**Re: Lot 6 Block 1 SAD 228
Volcano Cliffs Subdivision Unit 2
6412 Petirrojo Rd. NW
Grading and Drainage Plan
Engineers Stamp Date 11/2/2021 (D10D003F6)
Pad Certification Date 11/16/2021
CO: Not Accepted**

Asbuilt
LOT 6, BLOCK 10
VOLCANO CLIFFS UNIT 22

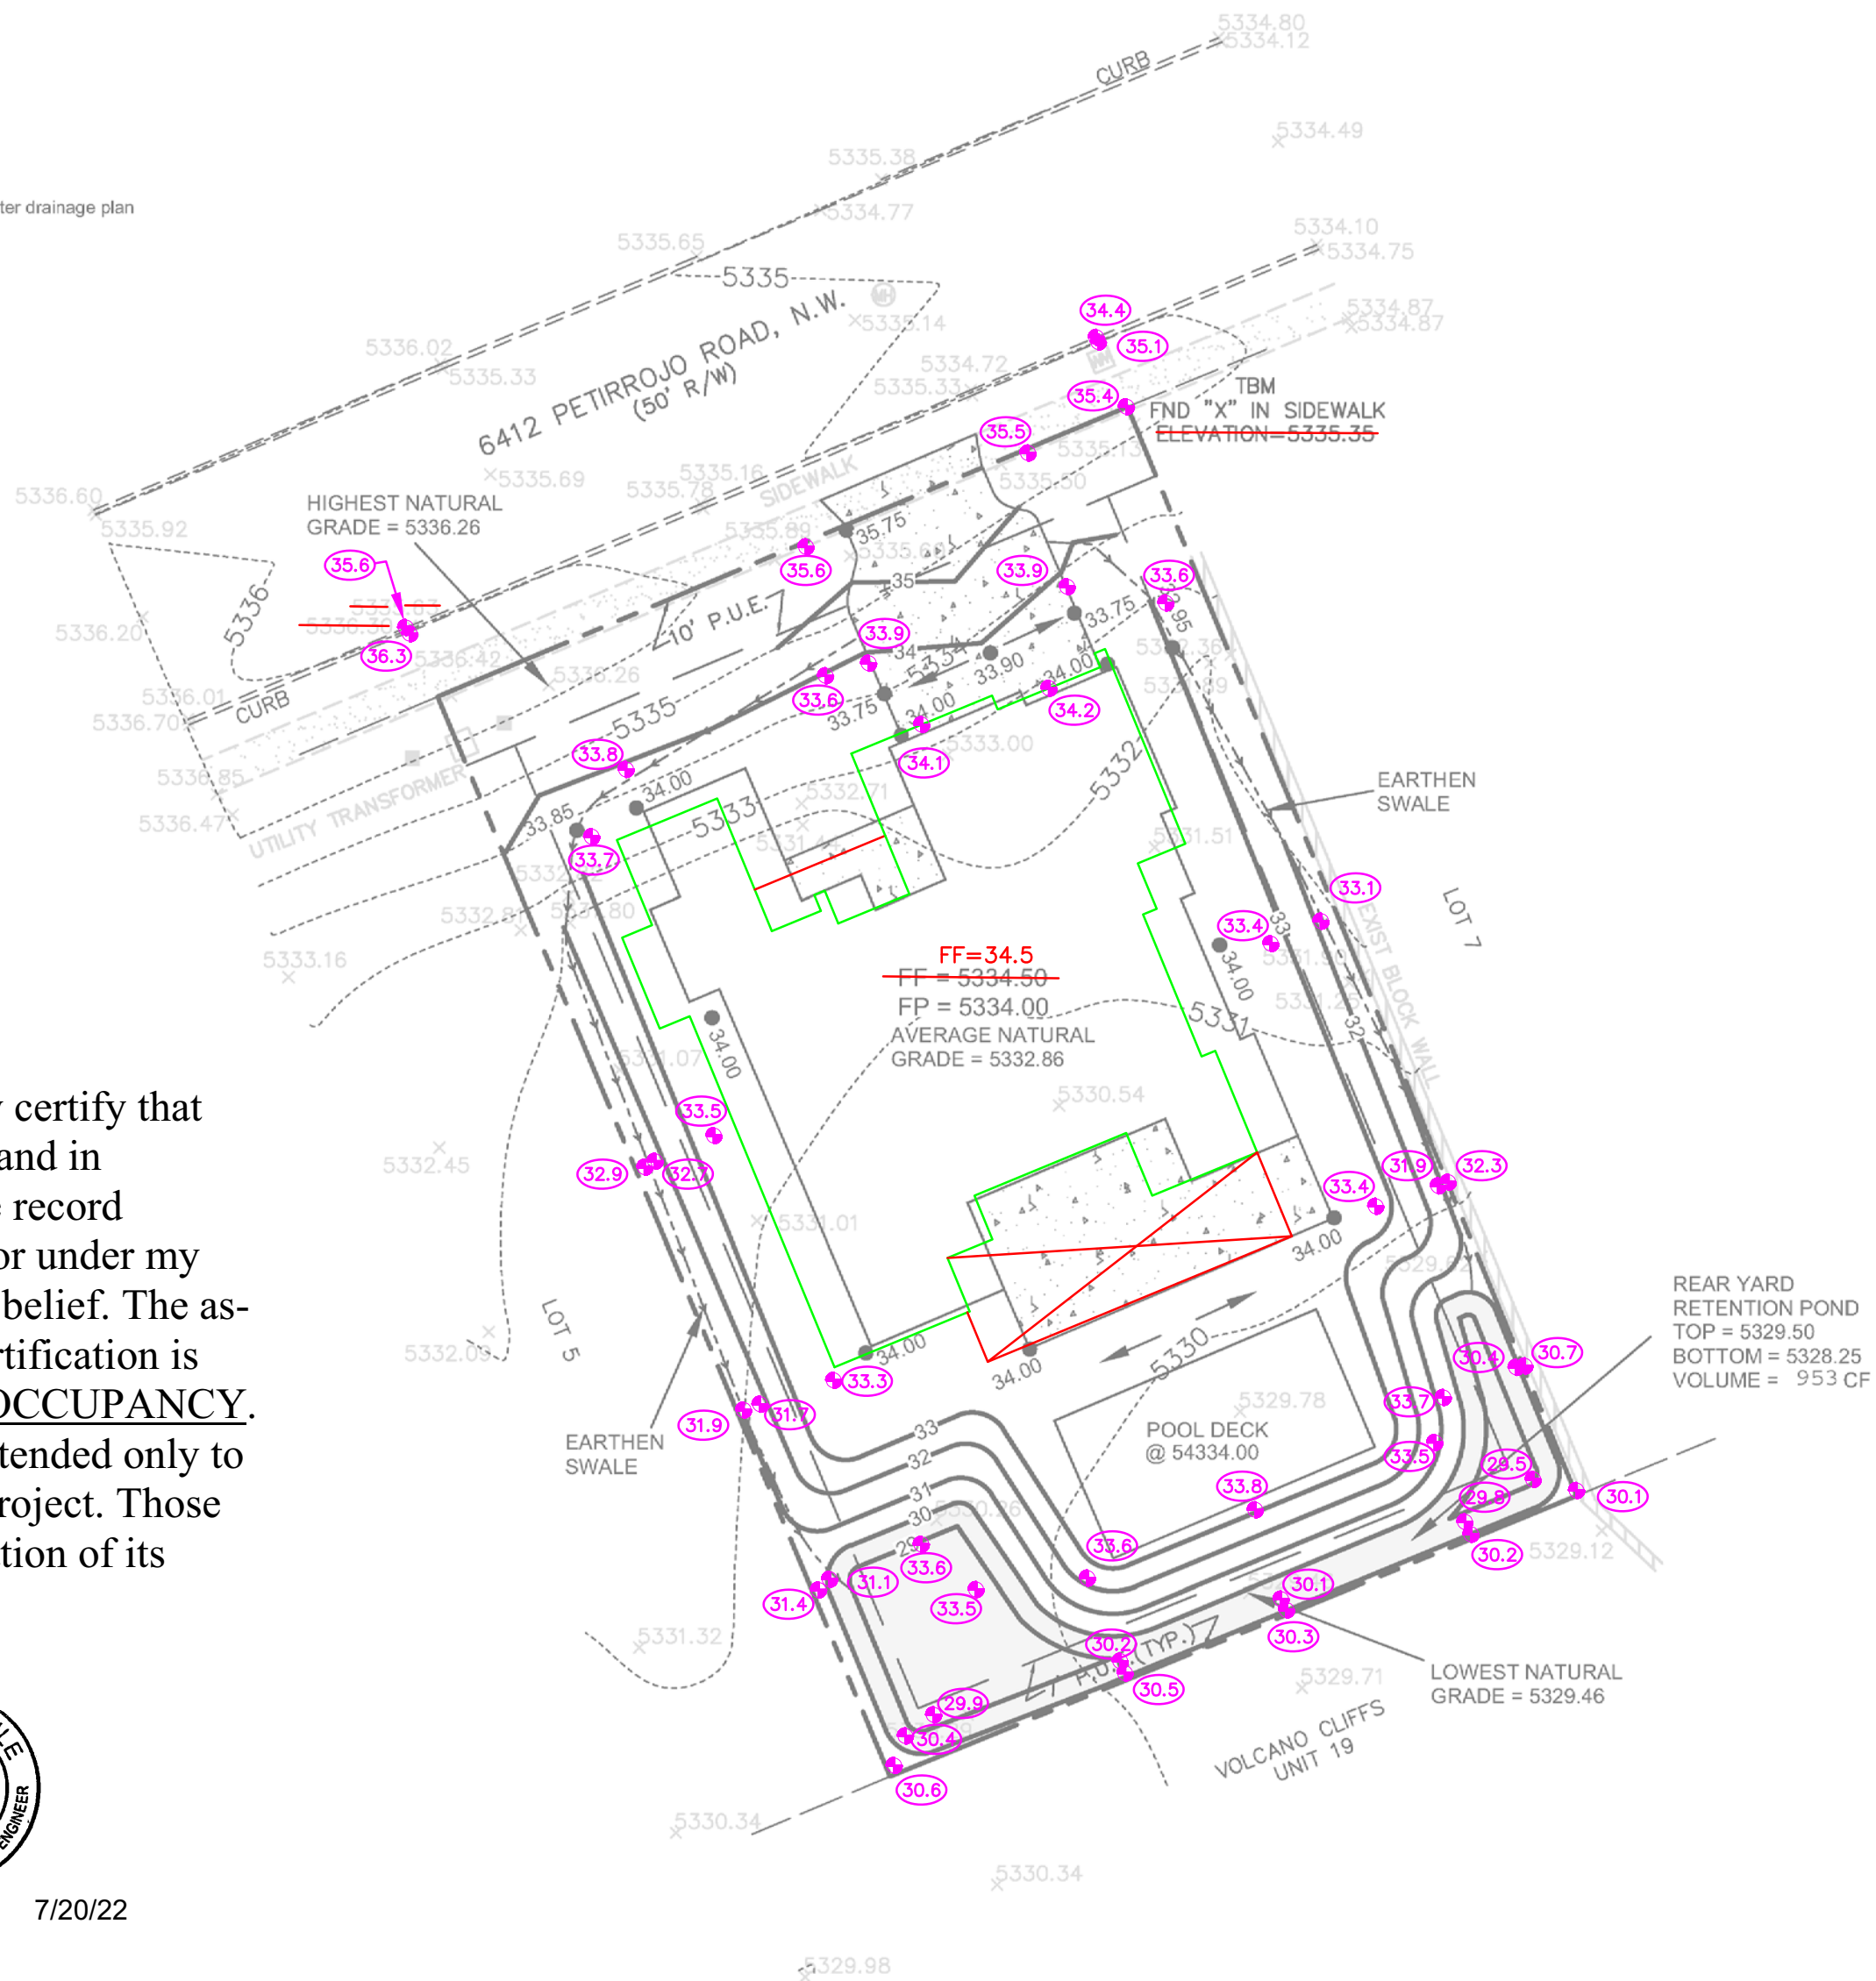
- Remove the dirt piles and debris from the neighbor's yard.
- Remove dumpster from neighbor's yard.
- The back yard needs to have erosion protection.
- Where the fence is missing blocks needs to be repaired so that no moisture enters the neighbor's yard.
